IEEE P802.3at/D0.9
Editor's Report

September 2007

Proposed PD State Machine

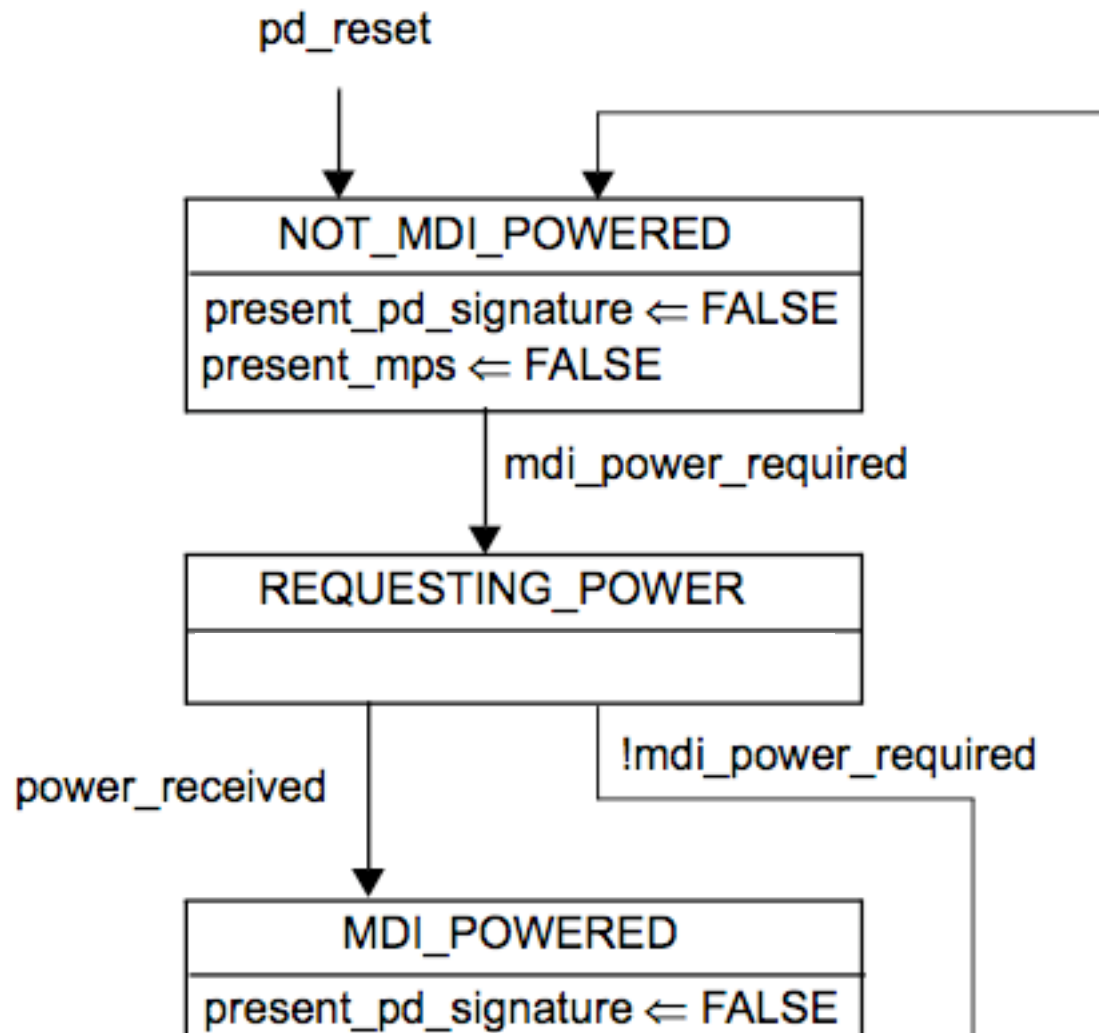
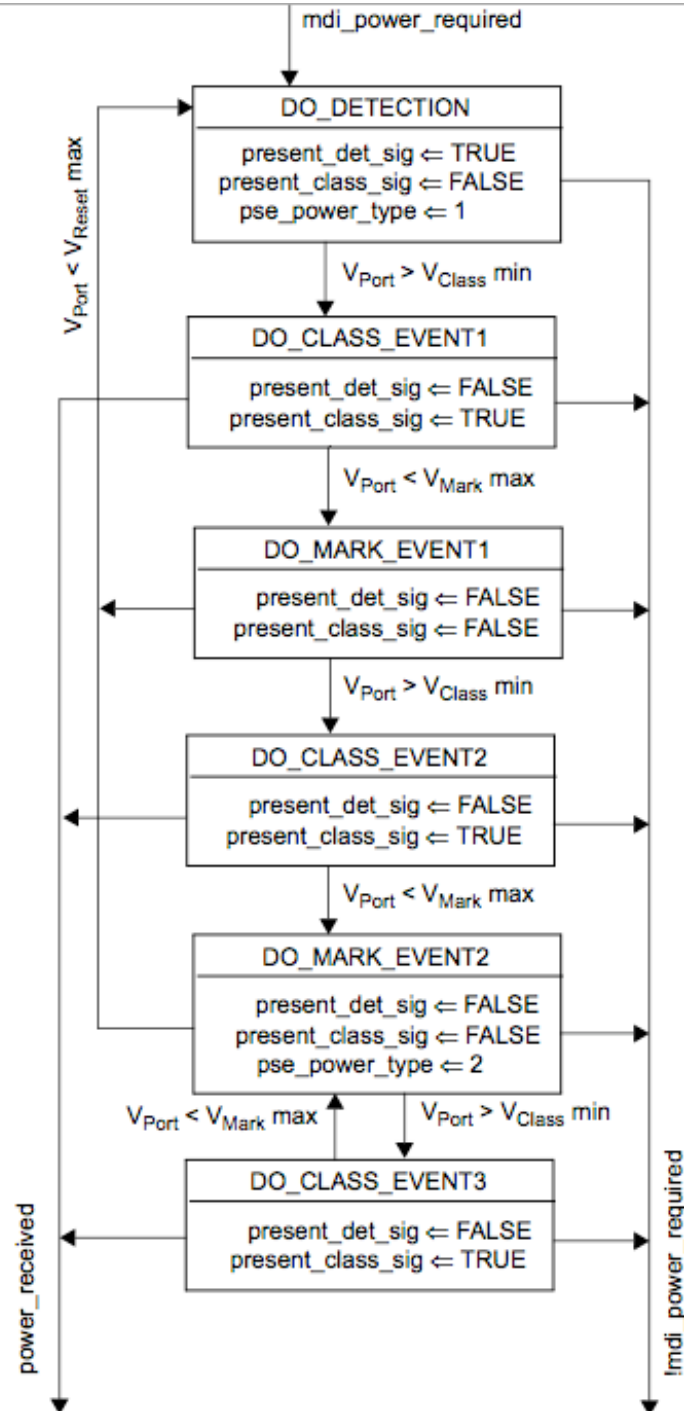
- ◆ Are we ready to move on to Working Group ballot?
- ◆ Do we have solid PSE state machines?
- ◆ Proposed PD state machine change
- ◆ Motion to define next draft and target audience

REQUESTING_POWER

New variables

present_pd_signature

~~Controls presenting the detection (see 33.3.3) and classification (see 33.3.4) signatures by the PD.~~

present_det_sig

Controls presenting the detection signature (see 33.3.3) by the PD.

Values: FALSE: A non-valid PD detection signature is to be applied to the link.

TRUE: A valid PD detection signature is to be applied to the link.

present_class_sigw

Controls presenting the classification signature (see 33.3.4) by the PD.
